***Royal Rehabilitation Centre Sydney
(MP 05_0001 MOD 2)***

600 – 640 Victoria Road, Ryde

***Modification of residential layout including
modifications to roads, open space and built
form layouts, building heights and density
within Stage 2.***

Secretary's
Environmental Assessment Report
Section 75W of the
Environmental Planning and Assessment Act 1979

Figure 4: Proposed building layout Stage 2

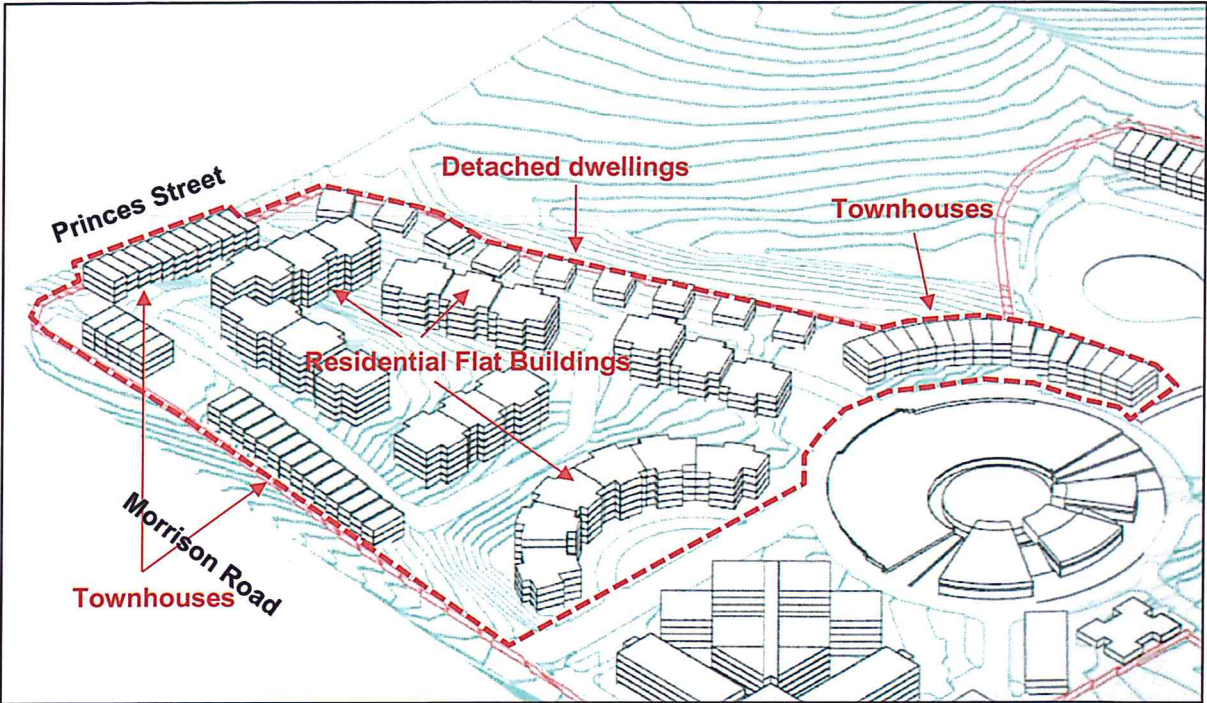
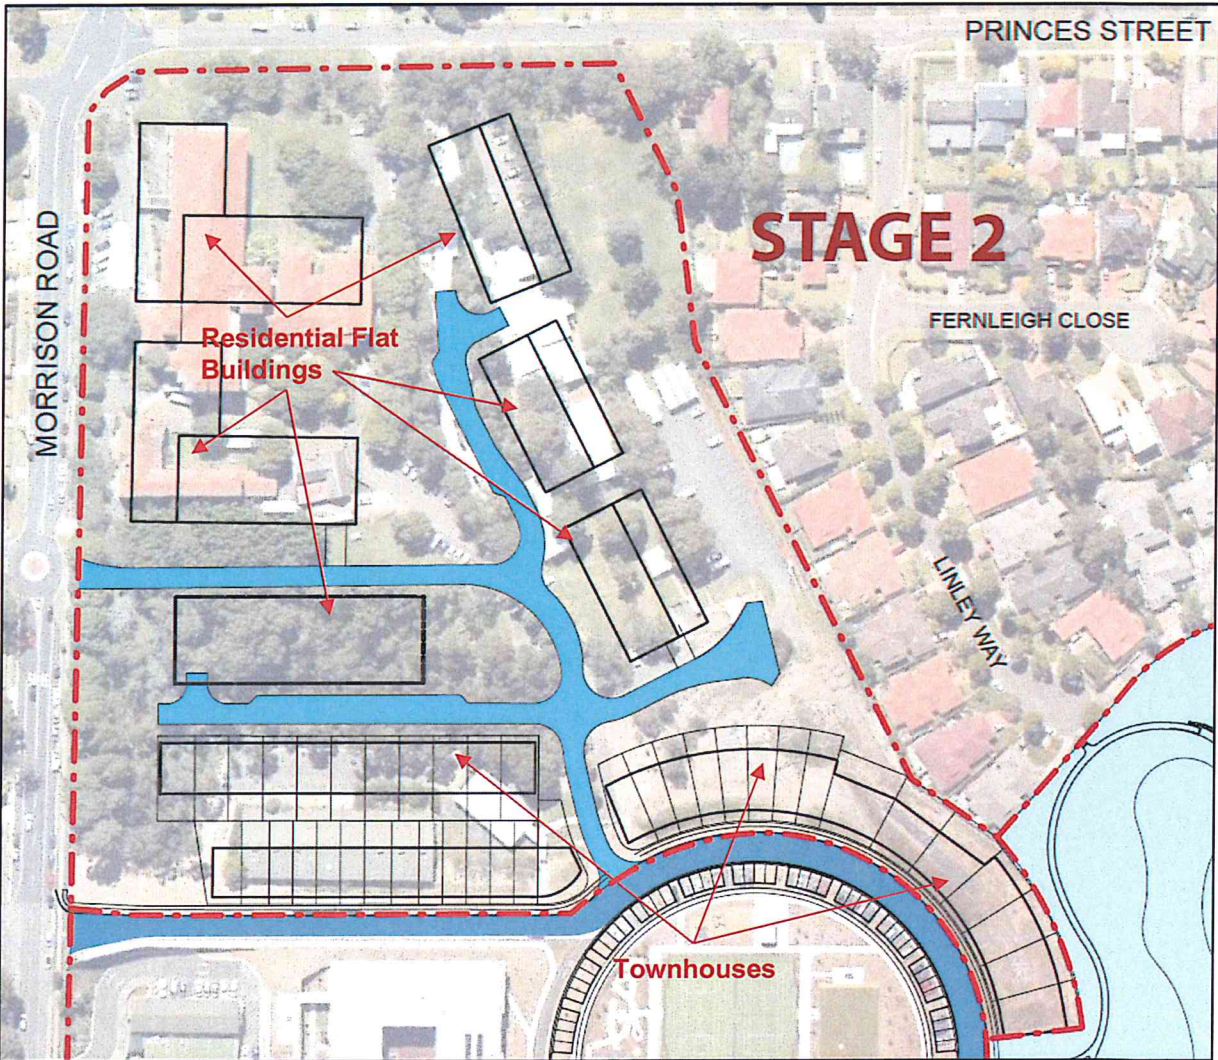
The development as proposed in the RtS as amended by the addendums is set out in **Table 1** and depicted in **Figure and 4**.

Figure 7: Proposed Concept Plan Height Controls (no. of storeys also indicated)

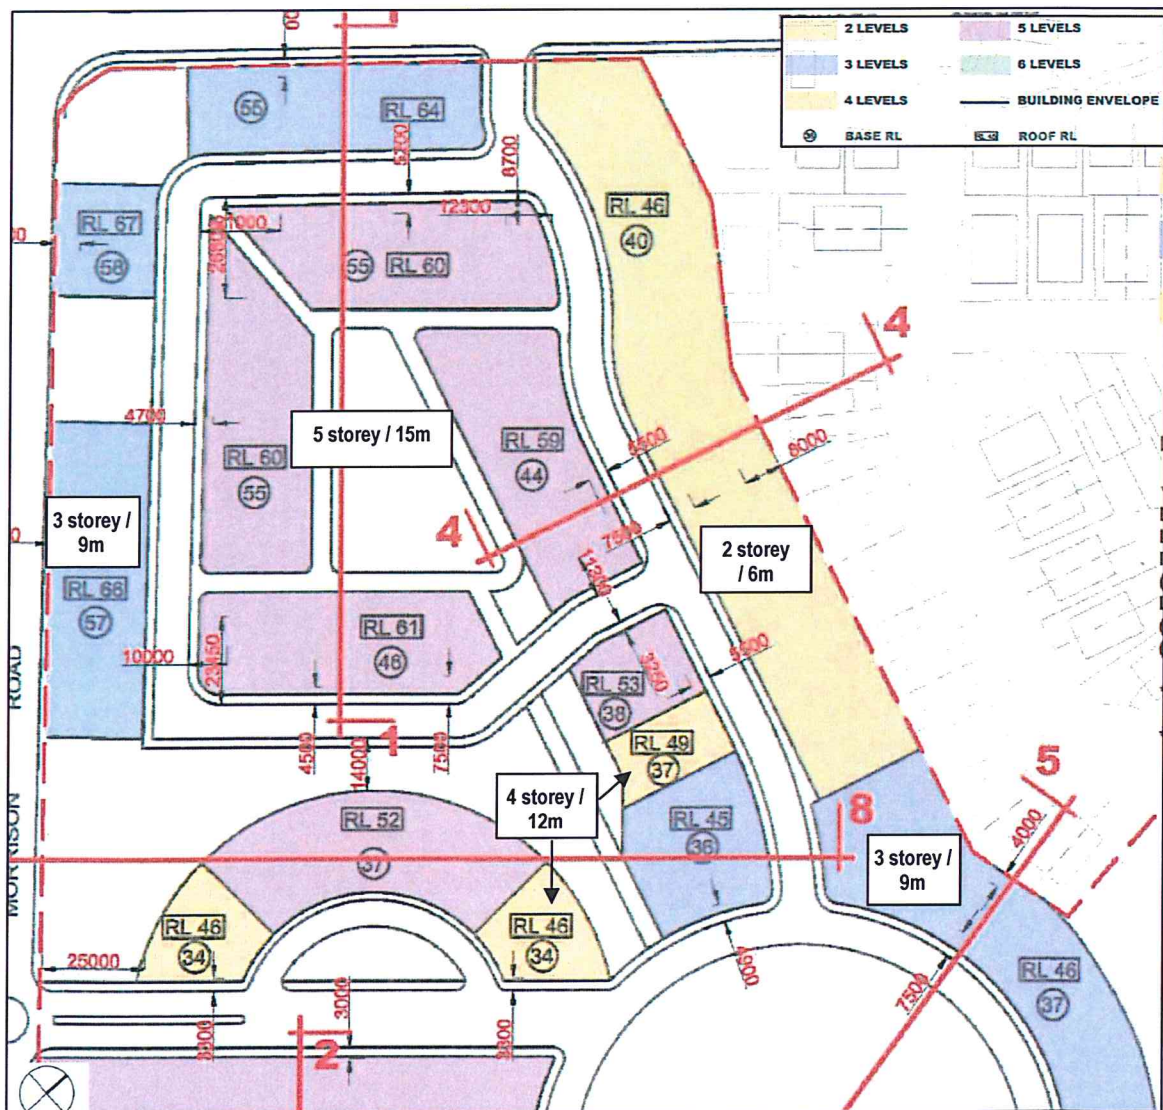
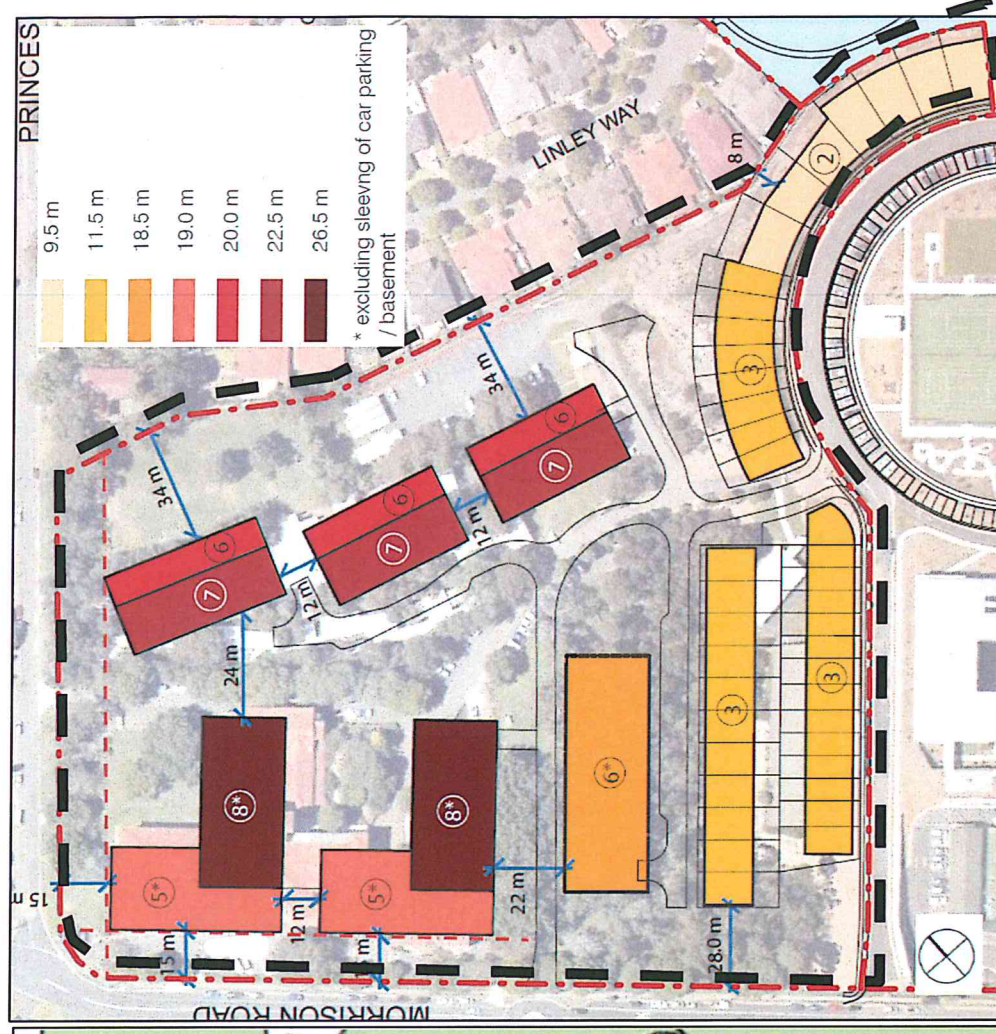
The modifications proposed to the building heights are demonstrated in **Table 2** and depicted in **Figures 5, 6 and 7**.

Nearby residents raised concerns that the proposal exceeds the heights within the Concept Approval and the LEP, and as a result would have adverse impacts to the character of the area. Particular concerns were raised regarding the visual impacts to the Morrison Road streetscape, and the residential area of Linley Way and Fernleigh Close. Concerns were also raised about overshadowing and privacy impacts resulting from the increased building heights.

Council did not object to the proposed building heights and acknowledged the merits of modifying the concept plan with an improved design. It noted however that the proposed buildings on Morrison Road which will replace the existing prominent Weemala Building will be taller and more prominent in the locality and requested that this building demonstrate design excellence and respect the history of the location. It also suggested the inclusion of a storey control and minimum setback requirements to remove ambiguity about the future scale and location of buildings at DA stage.

In response to concerns raised in the submissions, the proponent made a number of changes to building heights and setbacks, including:

- reducing the height (from 22.5 to 20 metres) of the northern side of the 3 residential flat buildings closest to the northern boundary;
- reducing the height of the proposed dwelling houses immediately adjoining residences on Linley Way (from 11.5 to 9 metres or 2 storeys);
- increasing the street setbacks of the residential flat buildings on Morrison Road and the corner of Princes Street (from 10 to 15 metres); and
- providing a storey control in addition to the height control in metres.

Following the changes made by the proponent, the Department concludes that building envelopes in the eastern half of the site are appropriate. These include the dwelling houses and the 18.5 metres / 6 storey residential flat building (all shown in yellow colours on the height plan at **Figure 7**). Those envelopes all result in buildings that would all have heights at or below the existing LEP height controls and would be well setback from adjoining premises so that they will not result any unacceptable visual or amenity impacts to the surrounding area.

The remaining five residential flat buildings are 1 to 4 storeys higher than the original Concept Approval, and exceed the Ryde LEP controls by 1.5 to 8 metres. The Department has assessed the impacts of these 5 envelopes in respect of:

Figure 9: Morrison Road streetscape with existing Weemala Building.

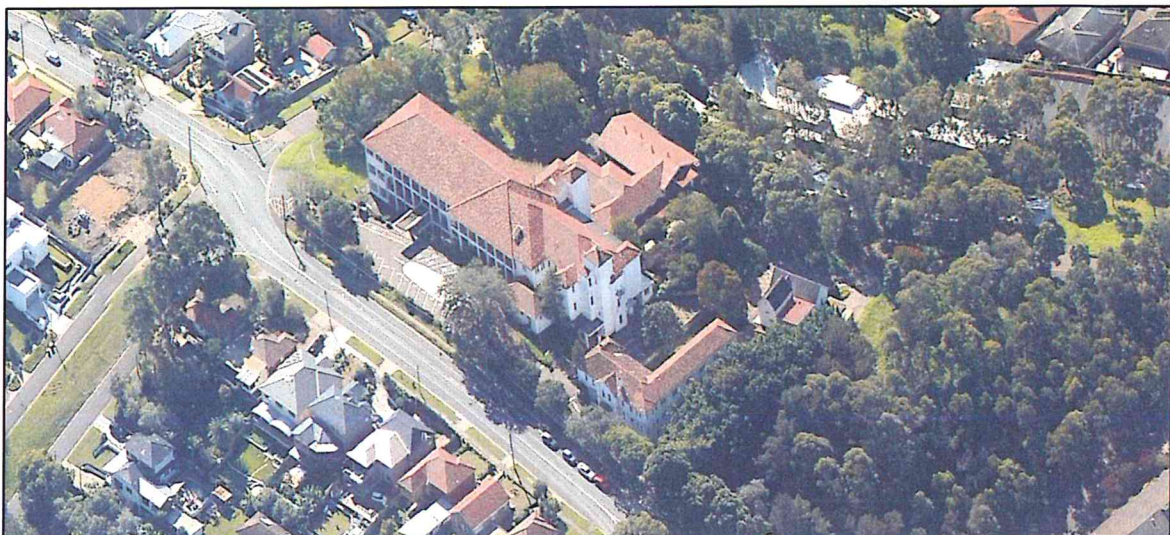
The character of this section of Morrison Road is largely defined by the existing Weemala Building (shown in **Figure 9**) which has a total height of 18 metres to the ridge line, equivalent to a conventional 6 storey building. It has a setback of 13 to 20 metres from Morrison Road. It presents as a large institutional building very different from surrounding development, and the site has therefore always been distinguished as very different in character from the detached dwelling houses on the opposite side of the street.

The proposed envelopes would have a similar maximum height as the existing Weemala Building. Furthermore, the proposed envelopes are setback 15 metres from the Morrison Road boundary, similar to the setback of the existing building and much greater than the 6.0 to 6.5 metre setbacks under the Concept Approval. The proposed generous street setbacks will enable significant front boundary landscaping to reduce the visual impact of the additional proposed height within the streetscape.

The Department concludes that in the context of the height of the existing development, the proposed 5 to 6 storey building envelopes are acceptable, and with the provision of generous landscaped setbacks and commitments to design excellence, would positively contribute to the streetscape and the surrounding area. It is also recommended that future assessment requirements in relation to landscaping and design excellence be included in the approval instrument.

Figure 10: Indicative Princes Street elevation of building on the corner of Morrison Road and Princes Street. Another 6-7 storey building will be located downhill at the left edge of the picture.

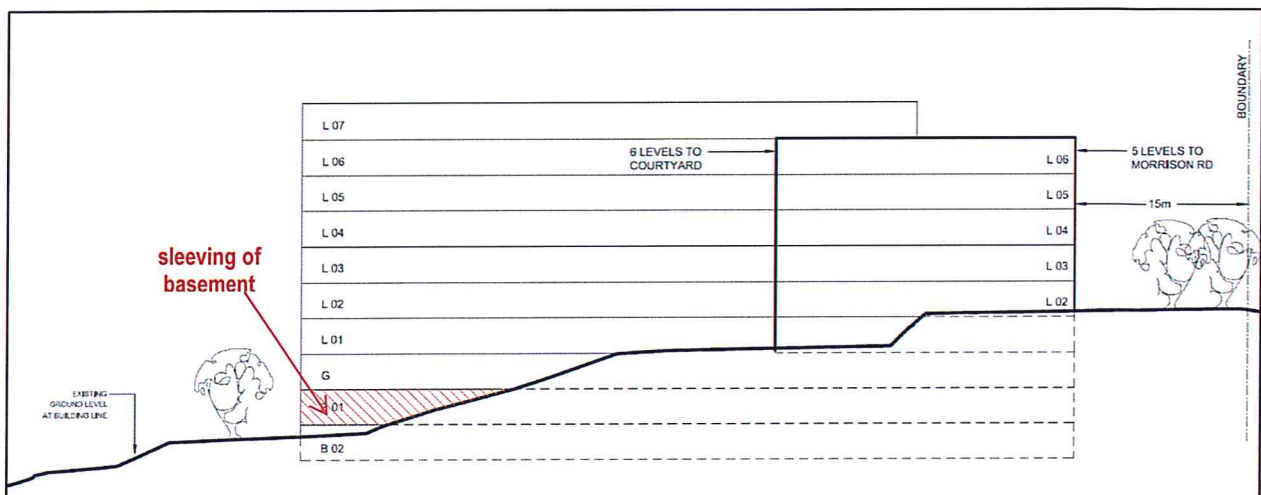
As viewed from Princes Street, the proposed building envelopes (7A and 6A) present as 5 to 7 storeys in height (19 to 22.5 metres), with a setback of 15 metres to the boundary, and with the remainder of the frontage occupied by extensive open space areas. Other building elements with a height of 7 to 9 storeys (including sleeving of basement parking as shown in **Figure 10**) would also be visible from Princes Street, but setback approximately 45 metres from the boundary.

The proposed 5 to 7 storey envelopes are significantly higher than the 2 to 3 storeys permitted under the existing concept approval and the 9.5m to 11.5m permitted under the LEP controls. Furthermore, other than the Weemala Building at the top of the street, the Princes Street frontage is characterised by a row of significant trees with limited development beyond (**Figure 11**). Development on the opposite side of the street is predominantly 2 storey detached dwellings.

The proposed setback of 15 metres would enable retention of most of the trees along the Princes Street boundary. The retention of these trees would assist with screening the development from within the streetscape and reducing its visual impacts. On this basis, it is recommended that future applications maximise retention of the trees, or where necessary, provide additional screen or replacement planting along the boundary.

Given the limited length of building facades (approximately 1/3 of the entire frontage) addressing the street and generous setbacks of 15 to 45 metres, it is considered that the visual impacts of the proposed building envelopes could be adequately mitigated by the retention of existing trees, in conjunction new landscaping and incorporation of design excellence requirements as discussed above. Appropriate future assessment requirements are included in the recommendation.

Figure 13: Proposed building envelope as viewed from Ryde Bridge (source: Proponent's RtS)

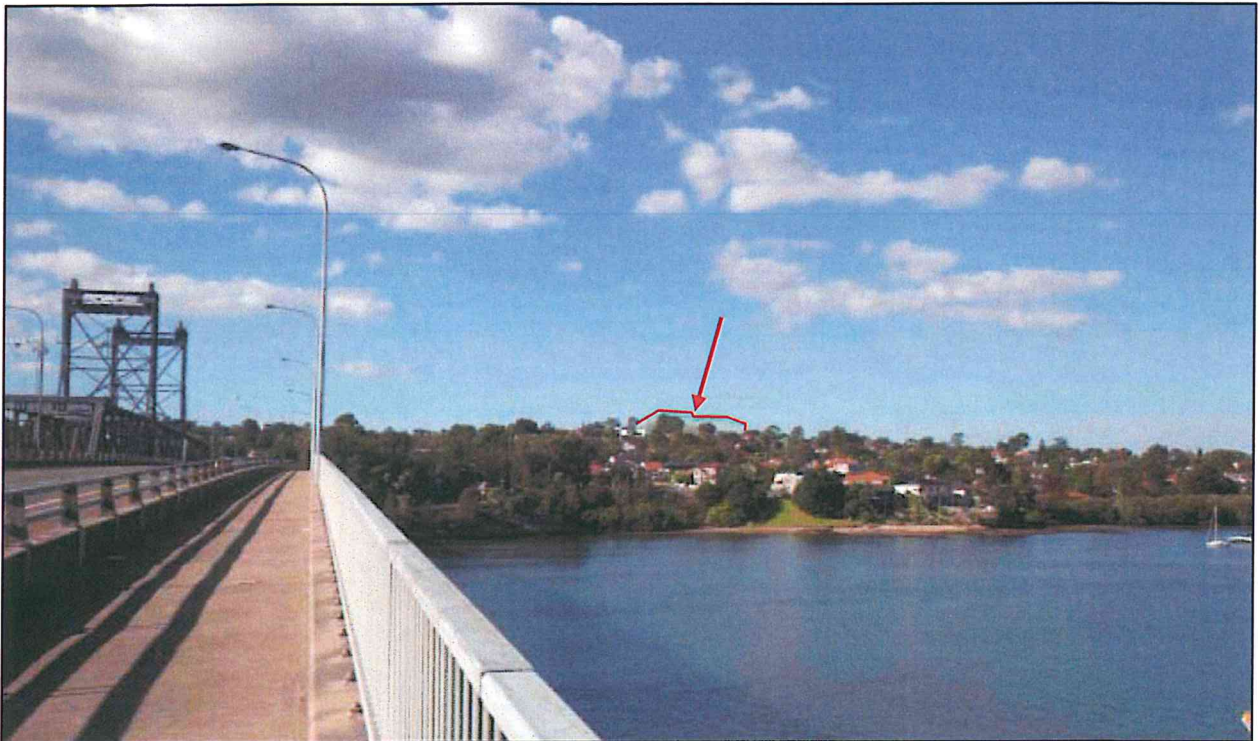
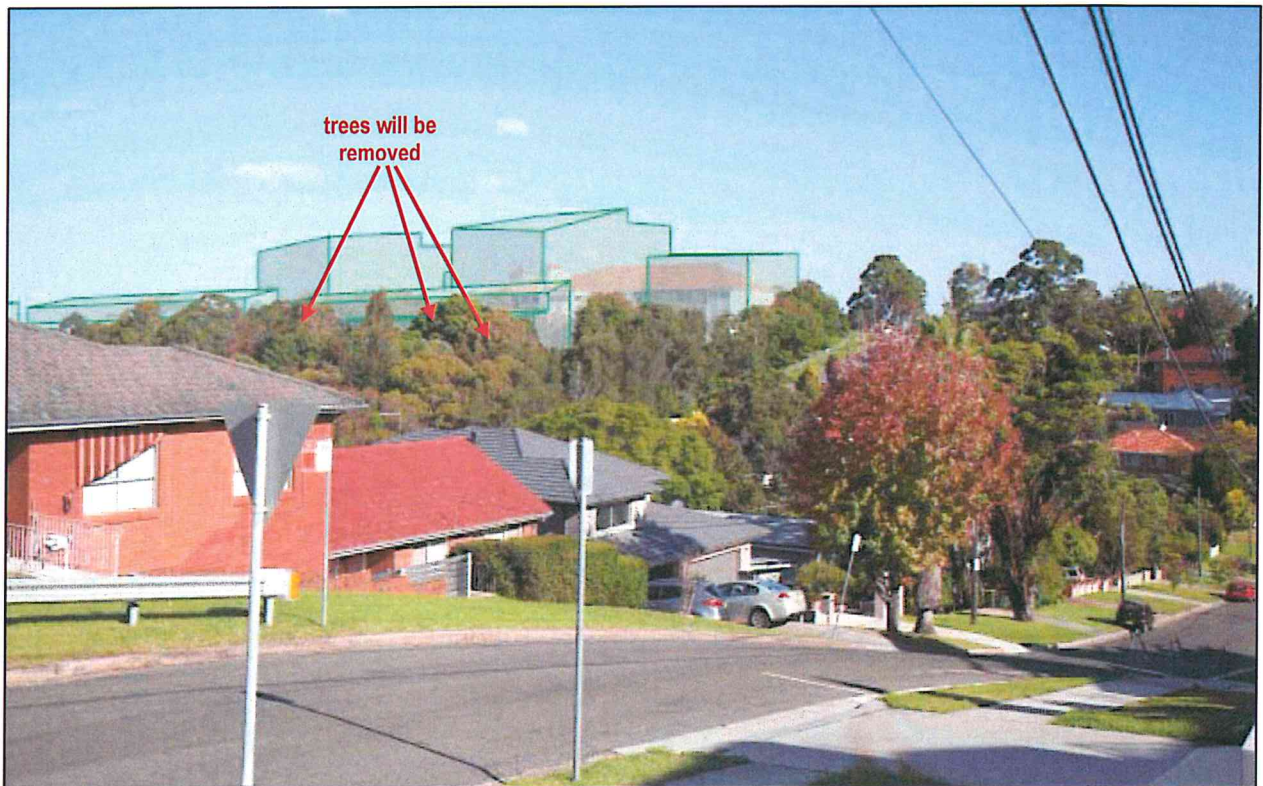
The corner of Morrison Road and Princes Street is a high point in the area and the existing Weemala Building at this location is visually prominent within the locality. The proposed 8 to 9 storey building envelopes in the centre of the site would be up to 8.5 metres above the ridgeline of the existing building and would be visible from many locations within the locality such as Ryde Bridge, and from the corner of Gladstone Avenue and Cowell Street (**Figures 13 & 14**).

As viewed from a distance, as with the existing Weemala Building, the proposed buildings will be highly visible and a landmark within the area. The Department considers that taller buildings with a landmark status are an acceptable outcome on this prominent site, provided that they demonstrate a high quality architectural design that is worthy of a highly visible landmark.

The Department notes that the envelopes shown in **Figures 13 and 14** are the maximum envelopes and final built form is likely to be articulated within the envelope.

The proposed envelopes, which will allow for built forms that are taller and more visually prominent within the streetscape and wider area, are an appropriate outcome on what is already a visually prominent or landmark site. The proposed envelopes will result in positive visual outcomes for the site and locality, providing that future development exhibits high quality

Figure 17: Proposed FSR Controls

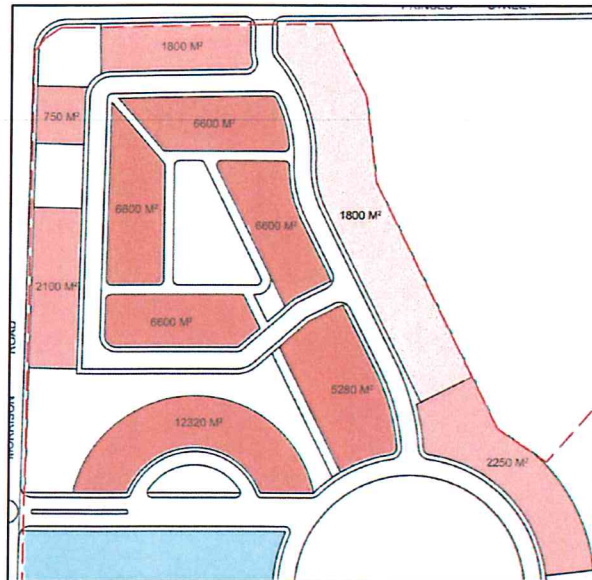
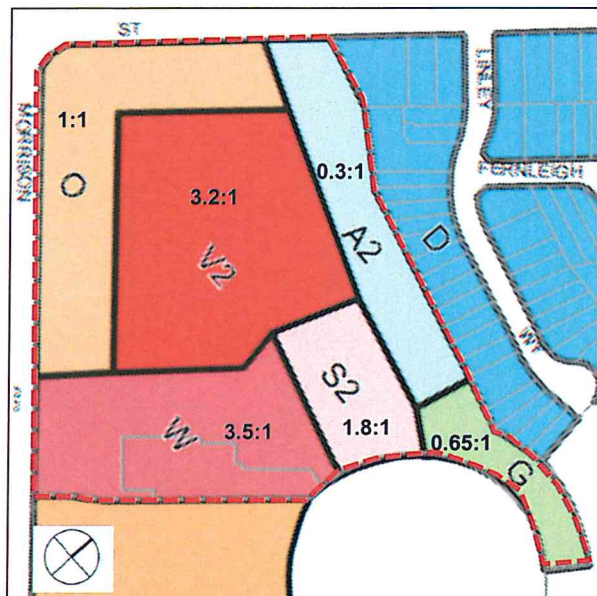
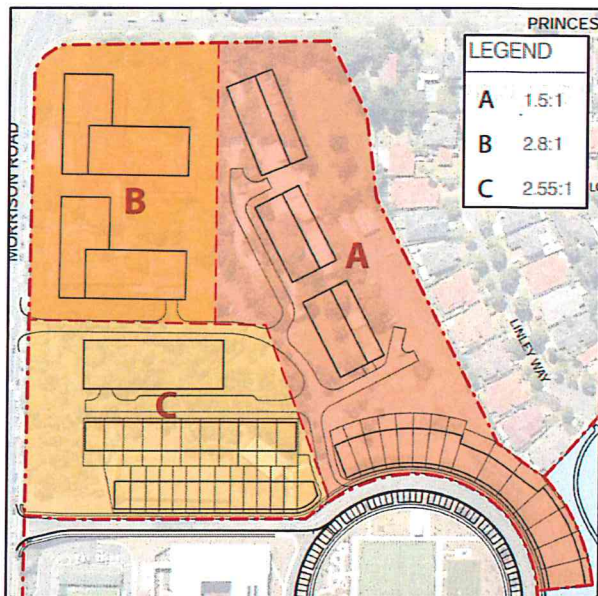
However, it is proposed to modify the floor space controls that apply to the site. The result of the proposed changes is a doubling of the maximum allowable GFA from 52,700m² approved to 111,000m² as proposed. This equates to an average floor space of 324m² per dwelling for the 342 dwellings permitted within Stage 2, which is an unrealistic dwelling size noting that the majority of dwellings to be provided are apartments.

The proposed FSR control is not considered to be a useful or appropriate tool for the assessment of future applications, noting that:

- it allows for an unrealistic and excessive floor area that does not correlate to the 342 dwellings permitted by the dwelling cap on the site; and
- it does not take into account the various building typologies on the site (the same controls are proposed to apply to both residential flat buildings and dwelling houses) and therefore does not provide any useful guidance for the bulk and scale of future built forms.

The Department considers that the cap on dwelling numbers and the building envelopes set by the Concept Plan should be the primary controls in determining the maximum development potential of the site. The density control resulting in a cap on dwelling numbers was imposed after extensive consideration of the impacts of the development and having regard to the community's concerns, with density of the residential component being the key issue of concern raised in submissions.

It is therefore recommended that the floor space control be deleted.
